PLANNING AND ZONING COMMISSION WORK SESSION MEETING
CITY HALL, 385 SOUTH GOLIAD, ROCKWALL, TEXAS
FEBRUARY 23, 2021 IN THE CITY COUNCIL CHAMBERS AT 6:00 PM

PLANNING AND ZONING COMMISSION CASE MEMO

TO: Planning and Zoning Commission
DATE: February 23, 2021
APPLICANT: Joseph Hornisher; *Kimley-Horn*
CASE NUMBER: P2021-006; *Replat for Lots 4 & 5, Block A, MTA Andrews Addition*

TO: Planning and Zoning Commission
DATE: February 23, 2021
APPLICANT: Bryan Connally; *CBG Surveying Texas, LLC*
CASE NUMBER: P2021-006; *Replat for Lot 1, Block A, BLPB-Mims Addition*

(SHEET 1 OF 2)

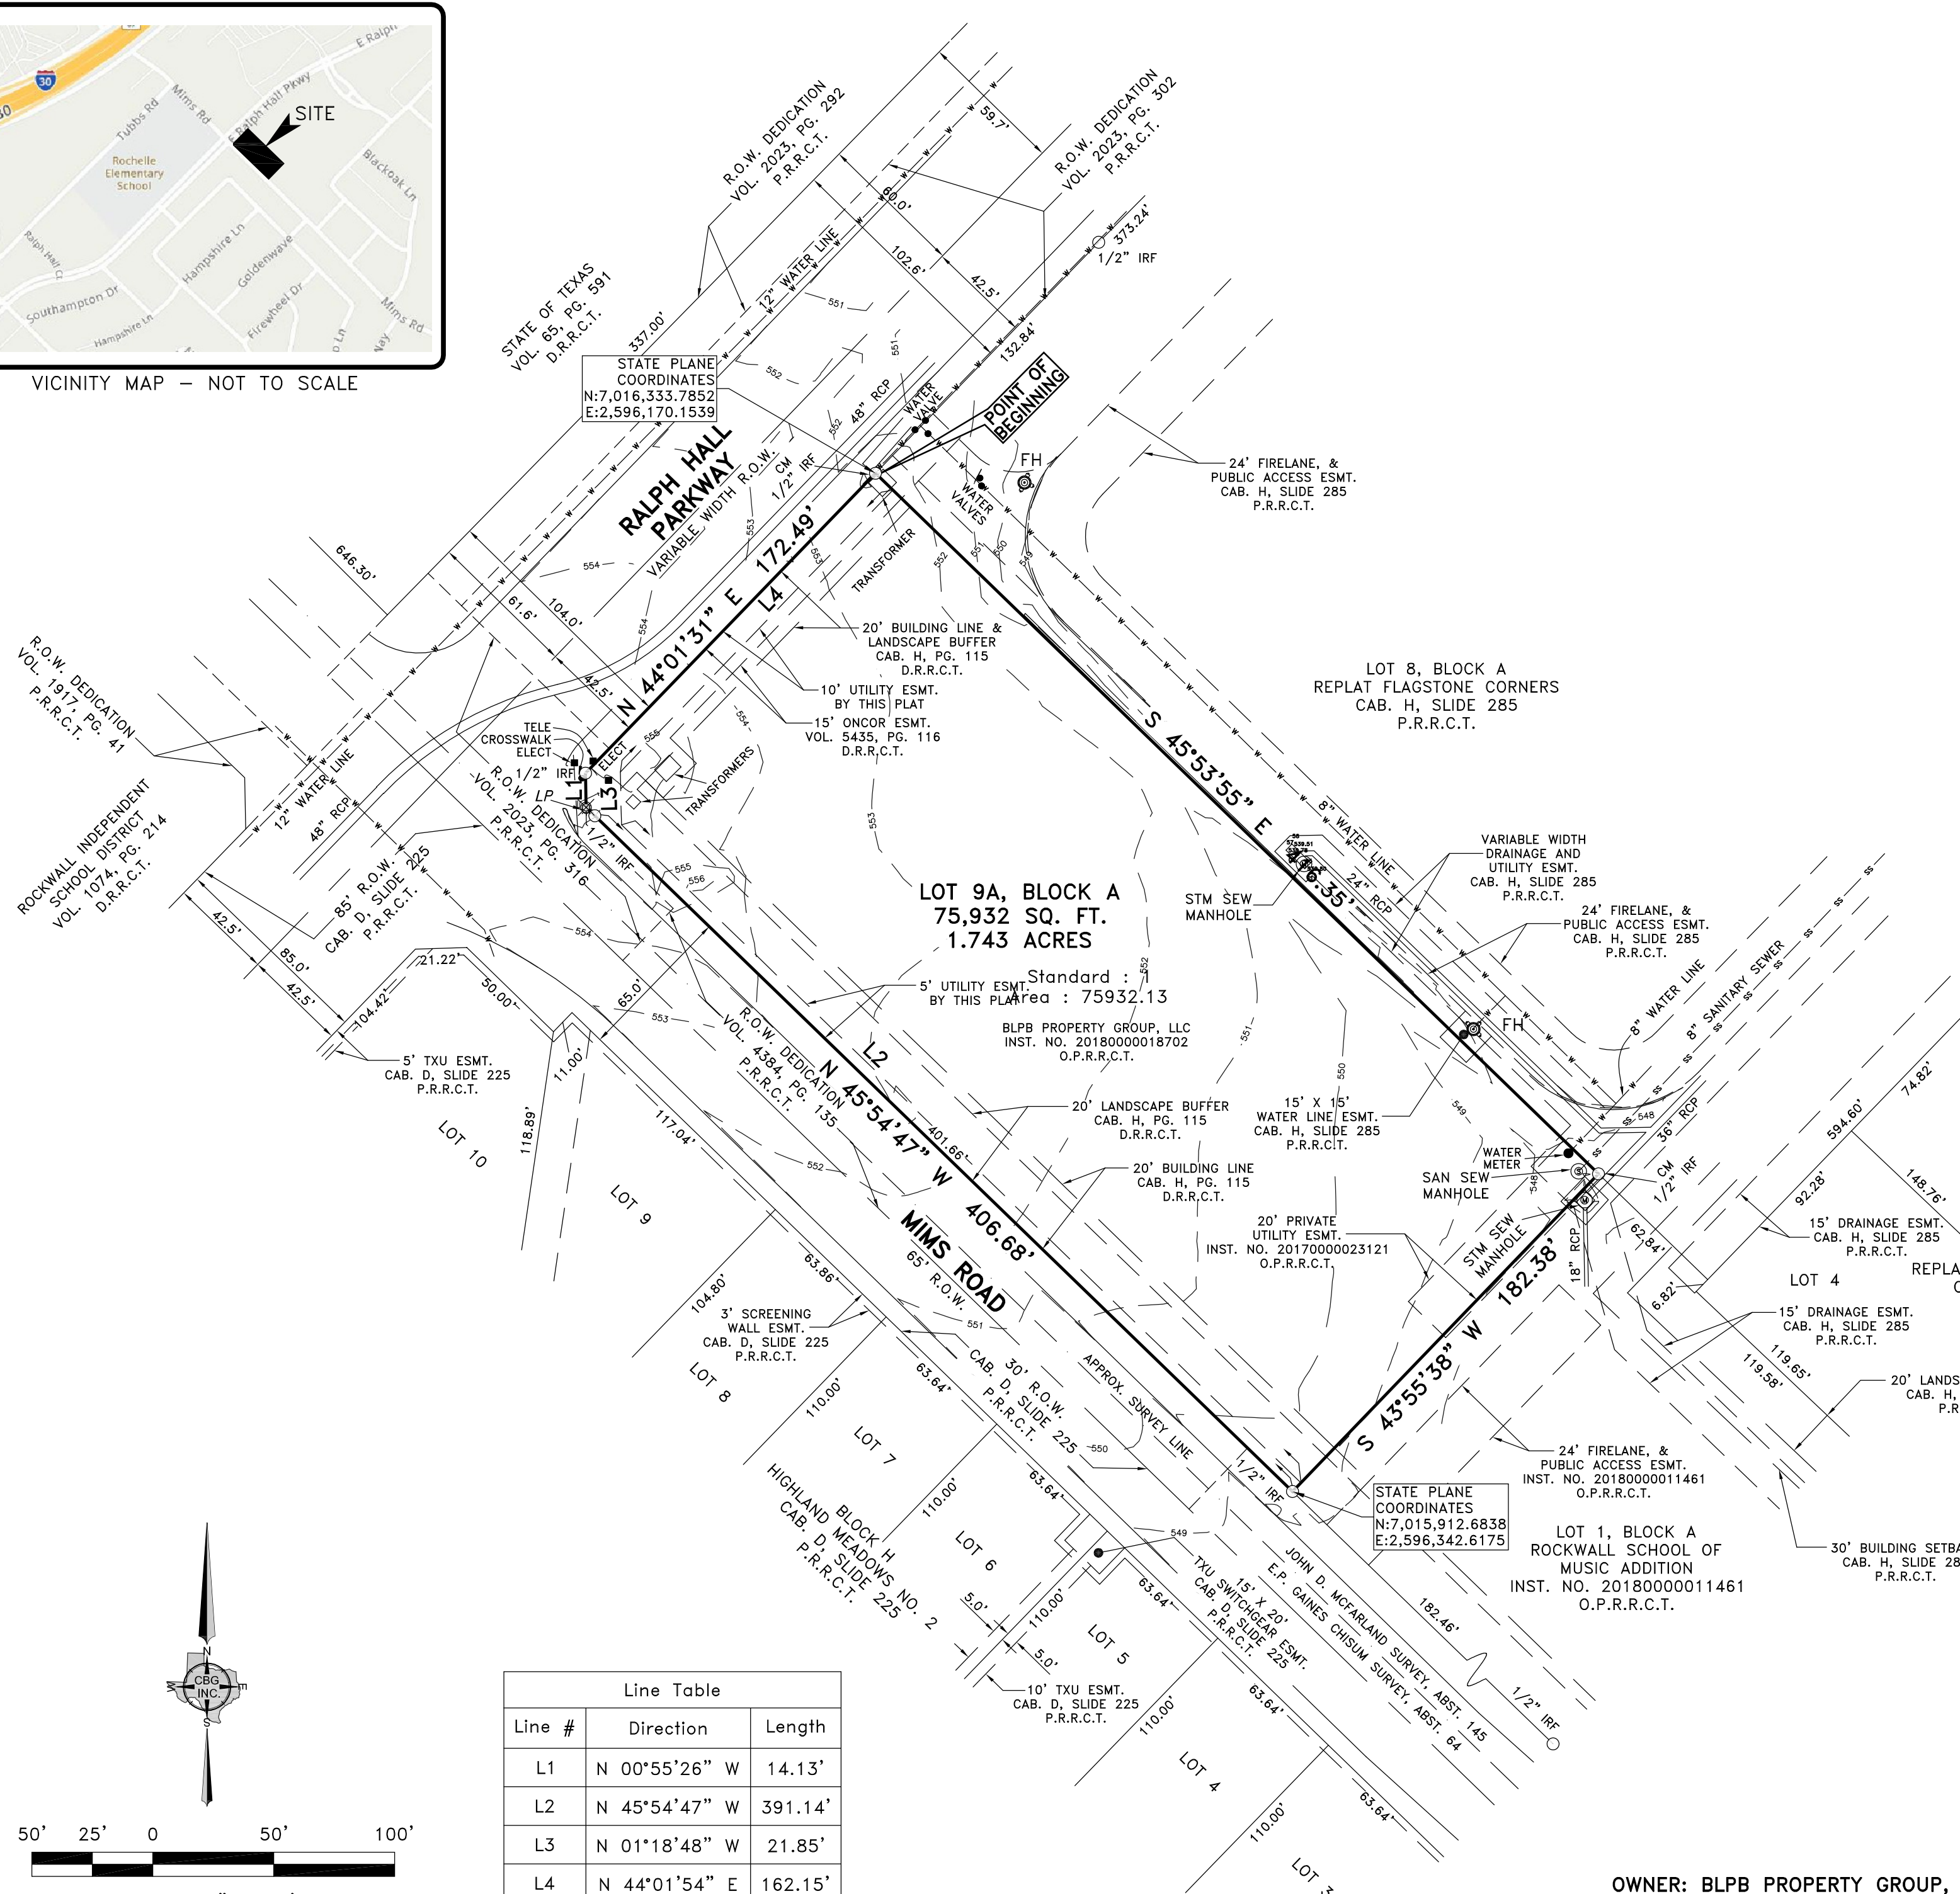
- M.5 Please change the Lot/Block designation of the subject property from Lot 9A, Block A to Lot 1, Block A.
- M.6 Adjacent to Mims Road a 20-foot building line is labeled and referenced as Cab. H, PG. 115; however, this was a 25-foot building line. Please make the required changes.

- M.7 Remove all contour lines.
- M.8 Change the standard dedication language to account for one (1) owner {e.g. owner(s) should be changed to owner}. Also correct the lot and block designation.

- M.9 Remove any of the preliminary language used (i.e. "released for review 02/11/2021 preliminary ...").
- M.10 On the first callout in the legal description (i.e. 416.35') the metes and bounds description is not legible. Move this callout so that it does not overlap site information.
